SERVICE BULLETIN No.1127

COACH MODEL : C2045

DATE : November 26th, 2003

SUBJECT : Proheat Bravo 80 – exhaust change and

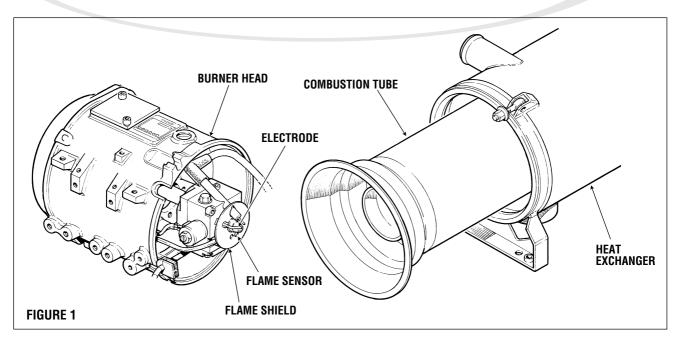
- 2. Remove heater Burner Head Assembly from heat exchanger.
- **3.** Inspect and clean any carbon build-up on the flame shield, flame sensor, electrode, combustion chamber and combustion tube. (see Figure 1)

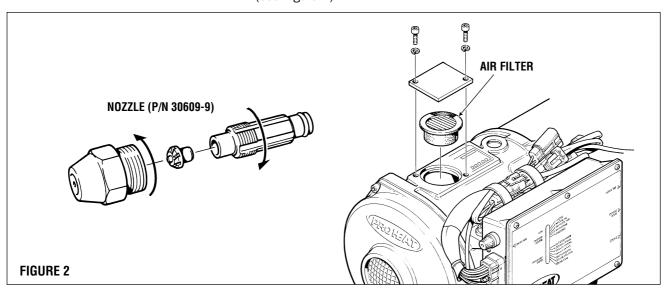
4. Clean nozzle and check air compressor air filter. Replace if necessary. (see Figure 2)

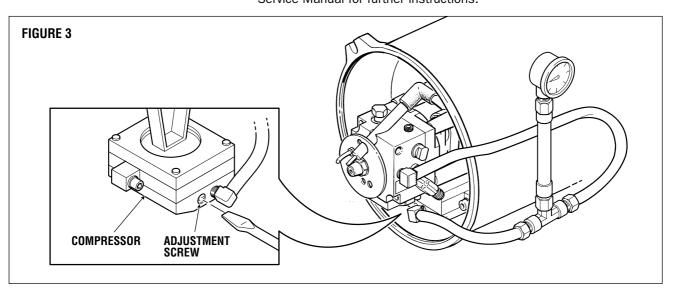
- **5.** Remove air hose from Fuel Delivery Unit and connect pressure gauge (P/N PK0060) inline with air supply line. (see Figure 3)
- **6.** Reconnect Power and Switch Harness only; start heater and read the air pressure on the gauge. (see Figure 3)

7. Adjust pressure as required by turning the pressure adjustment screw. (3.2 psi at 24 Volts). (see Figure 3)

Note: If the screw will not turn, apply a small amount of heat to the adjustment screw area to loosen the loctite. If compressor pressure will not adjust to 3.2 psi, then refer to page 4-18 of the Bravo 80 Service Manual for further instructions.
